CHEVROLET MOTOR DIVISION
General Motors Corporation
Chevrolet Service Department

Chevrolet Dealer Service Technical Bulletin

67-T-43

Subject: QUADRA-JET MALFUNCTIONS
1965, 1966 AND 1967 ENGINES
WITH QUADRA-JET CARBURETORS

11. SECONDARY METERING ROD ADJUSTMENT

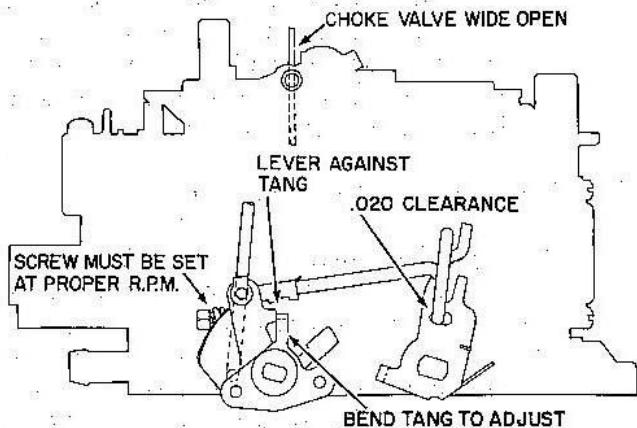
Poor mileage, hesitation when hot, and loss of power may be due to improper adjustment of the secondary metering rods. The secondary metering rod meters the secondary fuel flow in proportion to the air flow as determined by the air valve opening. If measurement is too small, the secondary mixture will be rich; if the measurement is too large, the mixture will be lean. Check secondary metering rod adjustment. With air valve closed, measure from top of casting surface behind air cleaner stud hole to top of metering rod (fig. 50R) on page 6M-22 of the Chassis Overhaul Manual. To adjust, bend secondary metering rod hanger with Tool J-22514 until rod height is 27/32 inches.
